Docket No. 52-048

SUBJECT: NuScale Power, LLC Response to NRC Request for Additional Information No. 187 (eRAI No. 9014) on the NuScale Design Certification Application

eRAI No.: 9014

Figure 3—19 Spectral ratio, TH1 X direction

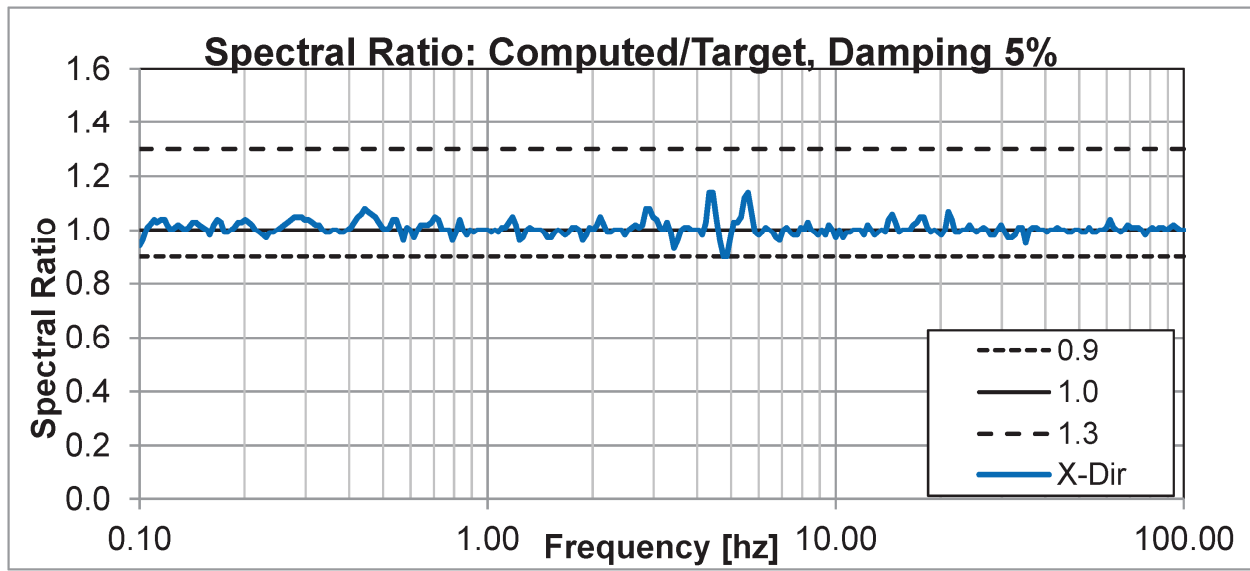
- a. In the 2nd paragraph on page 13 of TR-0816-49833-P, the staff requests the applicant correct the reference to Figure 3-67. Staff believes the correct reference is Table 3-67.
 - b. On Page 37 of TR-0816-49833-P, Figure 3-19 represents the spectral ratio for TH1 X direction. However, the label indicates the Y direction. The staff requests the applicant correct this inconsistency for Figure 3-19 and Figure 3-29 for the TH1 Z direction.
 - c. On Page 172 of TR-0816-49833-P, there is an asterisk next to the ultimate stress for the stainless steel material at a temperature of 212 degrees F with no explanation or footnote for the asterisk. The staff requests the applicant provide this information.
-

- a. The reference to Figure 3-67 in the 2nd paragraph on page 13 has been corrected to reference Table 3-67.
 - b. Figures 3-19 and 3-29 have been corrected to properly label the TH1 X and the TH1 Z spectral ratio directions, respectively.
 - c. "Note" in the footnote at the bottom of Table 3-28 has been replaced with "***".
-

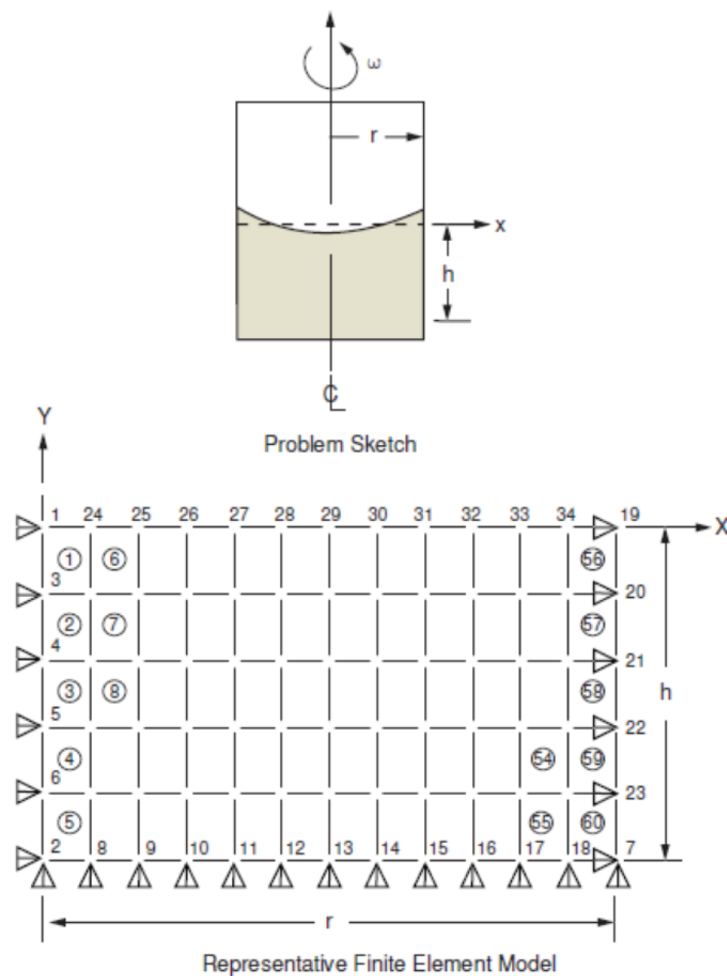
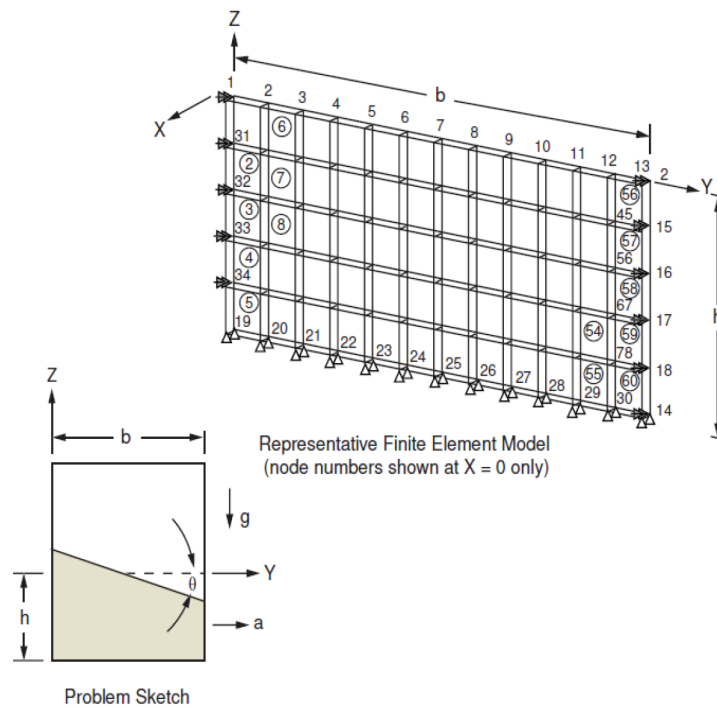
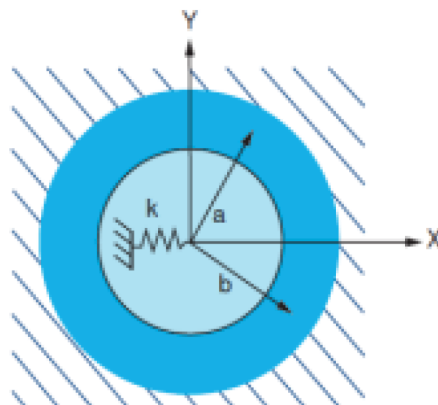
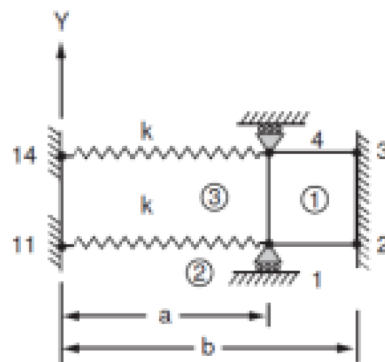
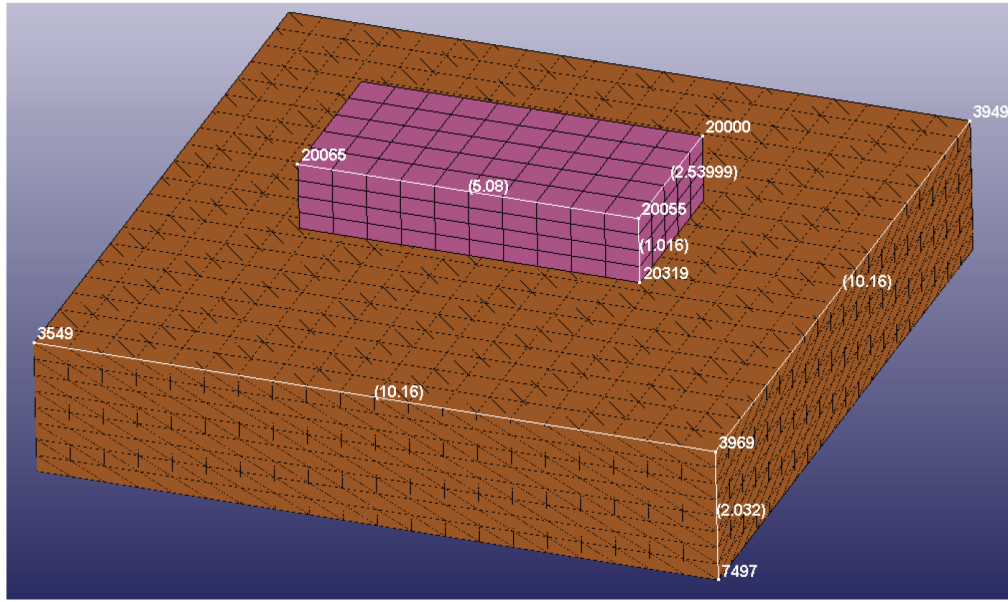
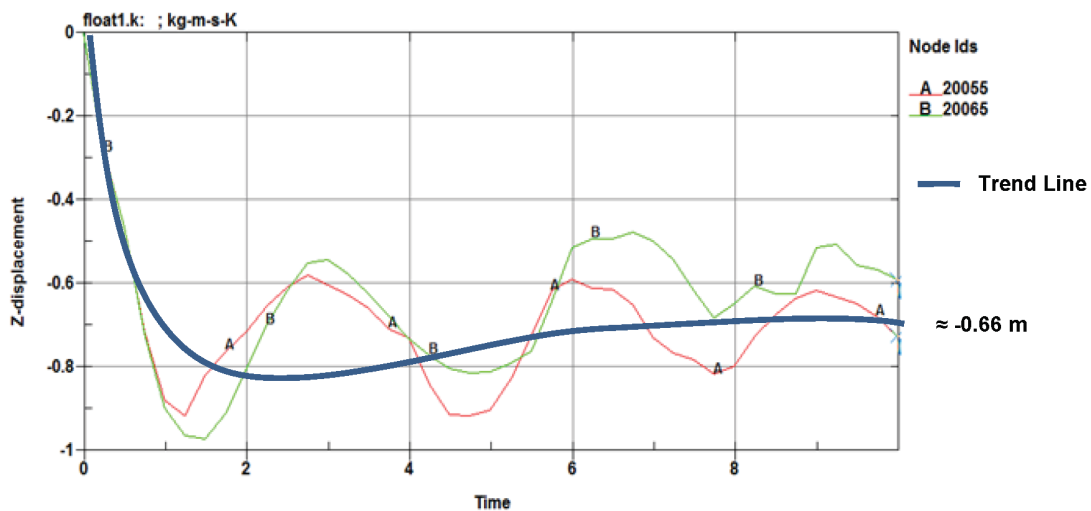
In Section 3.1.4.1 (page 130) of TR-0816-49833-P, the methodology for modeling the water in the pool is described. The applicant describes the use of the Arbitrary- Lagrangian-Eulerian (ALE) capability in LS- DYNA which considers the hydrodynamic coupling effects between the rack and the fluid within the spent fuel pool (SFP). The applicant is requested to summarize the validation of the LS-DYNA computer code, including the use of the ALE methodology in the code. The description of the validation for the ALE methodology should include specific solutions to test problems applicable to the modeling of the water in the SFP. The results of these test problems in LS-DYNA should be compared to solutions obtained from classical solutions, other codes or experimental results.

Several test problems were developed to validate the modeling of a drop of a fuel assembly and fluid-structure interaction capabilities of the computer program LS-DYNA. Four such test problems applicable to the modeling of the fluids in the SFP are presented here. Each of these 4 problems is derived from ANSYS verification problems available in the ANSYS Verification Manual. ANSYS has a well-established and accepted QA program. Validation problems are provided in the verification manual, which include known solutions that can be used to validate results. Each of the test problems presented include ALE methods for hydrodynamic coupling.

In order to validate the LS-DYNA V971 R7 program, each test problem is run on Red Hat Linux V6.4 Operating System (OS). The LS-DYNA results for Test Problems 1-3 are compared to the theoretical results from the ANSYS Verification Manual, as well as to results computed by ANSYS 15.0.7 on the same OS. Test Problem 4 uses a modified geometry based on VM158 from the ANSYS Release 15 Verification manual and is compared to results obtained by
